NOTICE OF ADDENDUM  
ADDENDUM NO. 1  
CONTRACT NO. 8574

W. WASHINGTON AVENUE ASSESSMENT DISTRICT - 2021

Revise and amend the contract document(s) for the above project as stated in this addendum, otherwise, the original document shall remain in effect.

13173	WATER PLAN & PROFILE - W. WASHINGTON AVE.
MADISON, WI	W. WASHINGTON AVENUE ASSESSMENT DISTRICT - 2021
8574	CONTRACT NO.
13173	MARK
1	REVISION
5/12/2021 PEH	DATE
W-1	BY
13173	Scale: #####
10:20 AM	Date: 5/14/2021

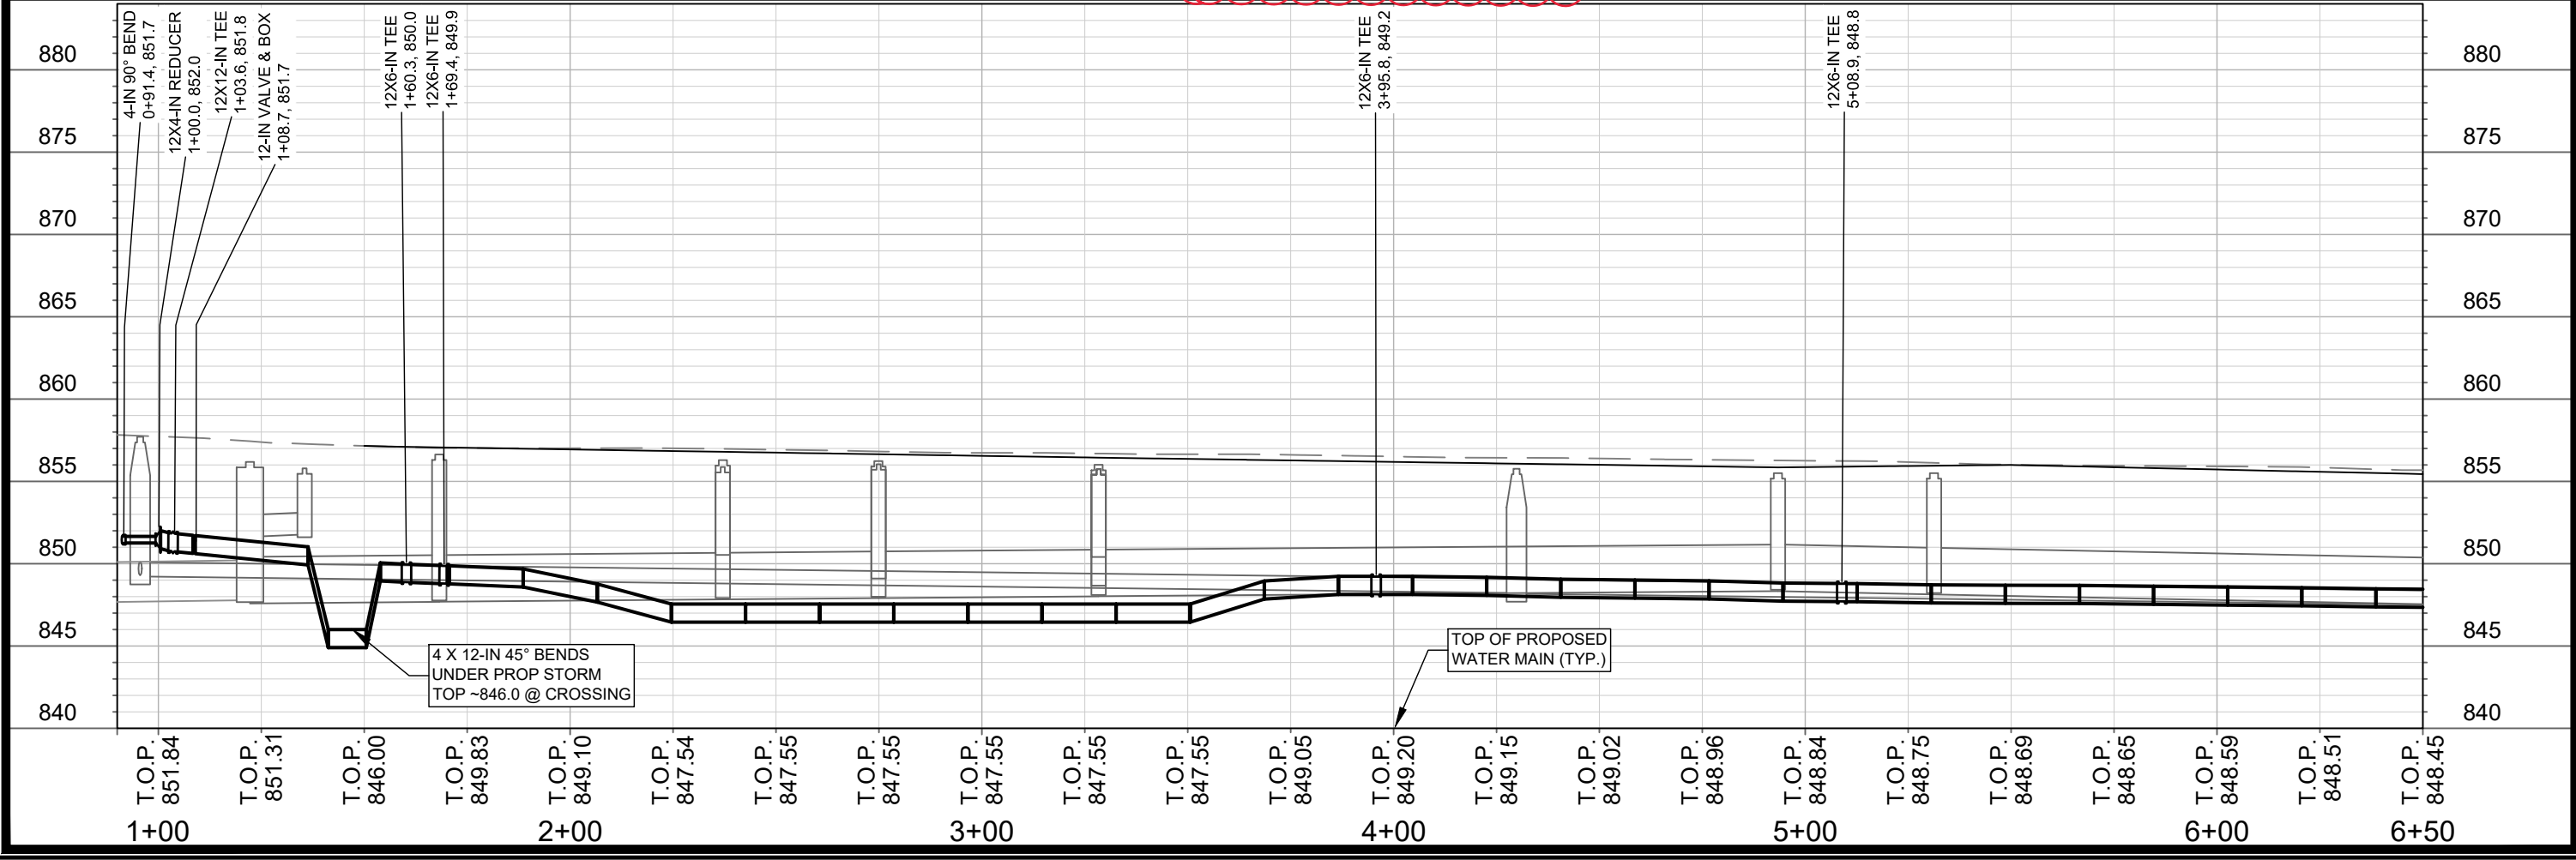
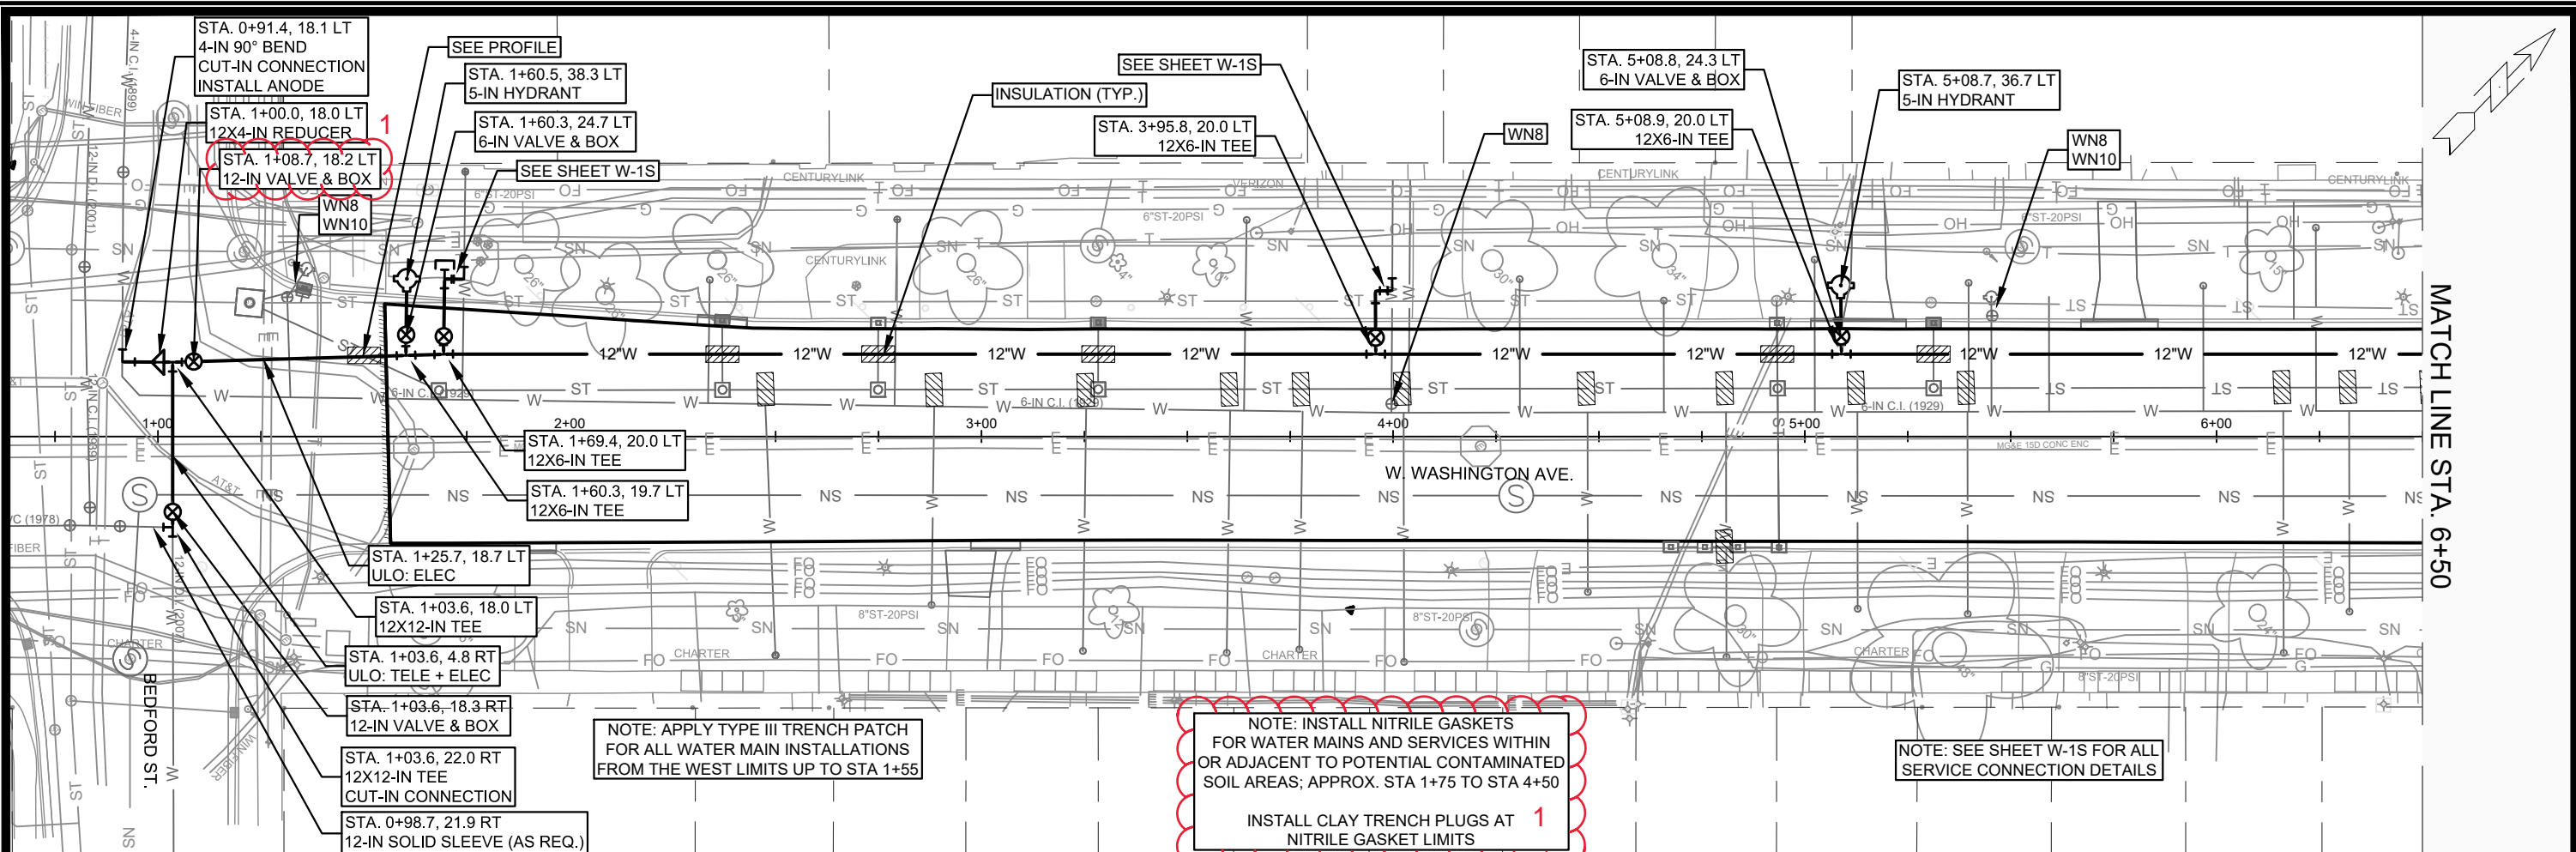
W-1 (REV 1 – 5/12/21): Updated to reference nitrile gaskets in the potential contaminated soil area; replaced 4-inch valve with 12-inch valve.  
W-2S (REV 1 – 5/12/21): Added a note about a temporary flushing device.  
W-4 (REV 1 – 5/12/21): Added a note about a temporary flushing device.  
W-5 (REV 1 – 5/12/21): Updated estimate quantities.  
W-7 (REV 1 – 5/12/21): Updated valve layout.  
M-1 (REV 5-17-21): Revised pavement markings around Bedford/W. Washington intersection
